PROPOSED SSDA MODIFICATIONS SCHEDULE (AS AT 02.11.2022)

PROJECT NAME: TRINITY GRAMMAR SCHOOL, THE RENEWAL PROJECT
JOB NO.: 210112

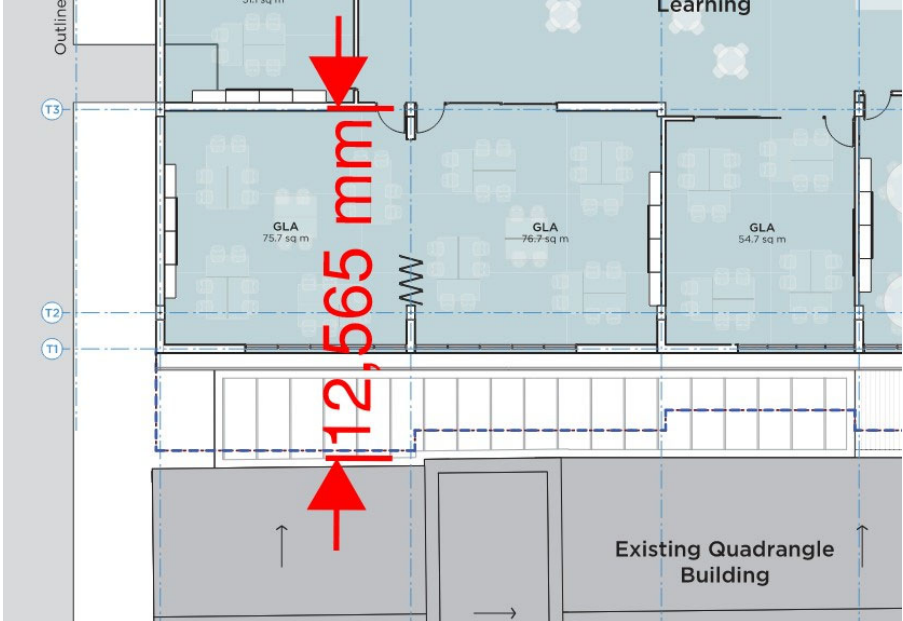
REFERENCE NO.	MODIFICATION DESCRIPTION	NOTES
2 - DA121	Reconfiguration of Library entry doors.	TGS have requested the proposed configuration of entry doors to the library to accommodate their developed operational and security strategy.
3 - DA121	Amendments to the Junior School Link	The proposed plan on this level reflects planning changes below to accommodate latent structures on the New Accessible Walkway as discussed in 2 - DA120.
4 - DA121	Amendment to Agora tiered seating	TGS have requested more tiered seating to face the existing Sports Centre and for increased pedestrian access between the Agora and Sports Centre levels. The proposed amendments reflect this operational requirement.
5 - DA121	Amended Locker Room access	Each of the proposed four flights of stairs in this modification link a Locker Room in the basement to the new axis path. They will enable direct student access to their 'house' locker room (as discussed in 4 – DA120) for more efficient student movement. The previously approved single staircase would not handle this volume of students as well.

6 - DA121	Additional external stair	TGS have now allocated roles to individual offices in the Quadrangle building with the Pastoral Care area located in this eastern wing. These four roles – HOMS, DHOMS, HOSS and DHOSS – have a large parent-facing component, with sensitive topics often discussed. It is good practice to provide an alternative exit from these meetings to protect participants' privacy. The existing building plan provides this for the HOMS and DHOMS office. An additional external stair is proposed to the east, to provide this egress option for the HOSS and DHOSS.
7 - DA121	Pastoral area replan	TGS have now considered in more detail how this area will operate daily and this proposed replan reflects their optimised layout.
8 - DA121	Replan of Library offices, Presentation Room, Reception back of house and Student Services	TGS have further considered how these areas will operate to optimise use of shared facilities (such as meeting rooms and amenities). This proposed plan will better serve their operational demands.

9 - DA121	New office	TGS propose a single office within the larger Learning Support office to direct their support function across the campus.
10 - DA121	Relocated stair	It is proposed to relocate the stair from within the 'tower' of the Quadrangle building to within the Library. As the west portal of the 'tower' is being retained, head height would become restricted there with stairs on the path. Relocating the stairs into the Library allows more head height at this portal and allows the 'tower' to be read more completely from within the library.

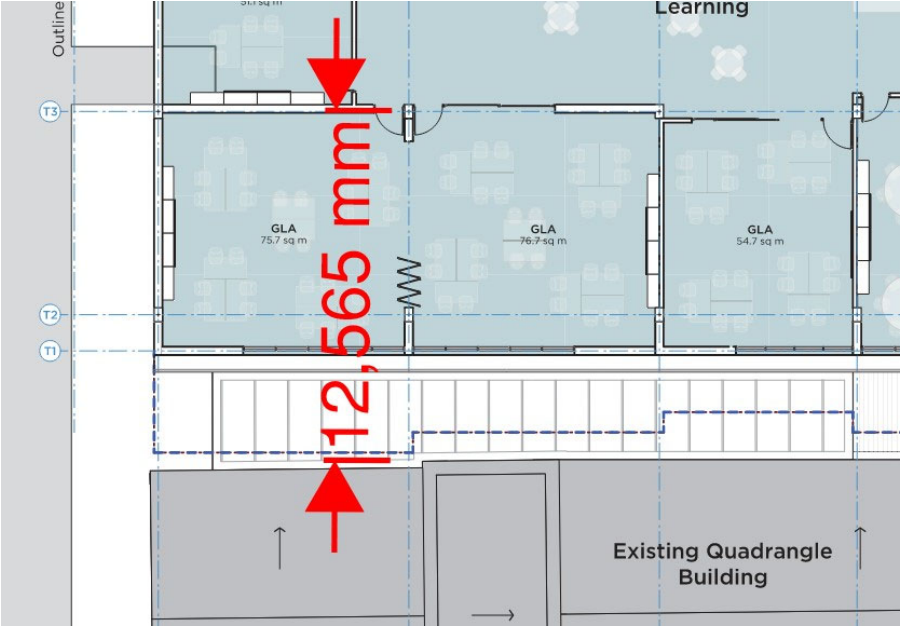
REFERENCE NO.	MODIFICATION DESCRIPTION	NOTES
9 - DA123	Building envelope dimension amended	It is proposed to increase this building envelope dimension here from 26,305 to 26,500. There will be no environmental impact from this increase (less than 200mm) as the bulk of the building will be determined by the setout of the Arrow building screen structure to the west and this is actually reduced (refer 7-DA123).
	DA 124 - PROPOSED T&L PRECINCT PLAN L3	
1 - DA124	Walkway added to Arrow Building	A walkway ramp is required to reconcile differing levels between the T&L Building (RL 61.1) and the PA Building (RL 61.39).
2 - DA124	Structural connections between the Arrow walkway and T&L building	These connections are required to tie the Arrow walkway to the T&L building for lateral stability. Otherwise, a bulkier structure and/or cross-bracing would be required around the perimeter which would undermine the original design intent.

3 - DA124	Replan of amenities	Amenity planning amended to incorporate developed services design.
4 - DA124	Reconfiguration of external stairs	The proposed introduction of switchback stairs to this eastern end of the Arrow walkway, in lieu of straight stairs with a level return, is to make vertical transition more efficient with more compact stairwell.
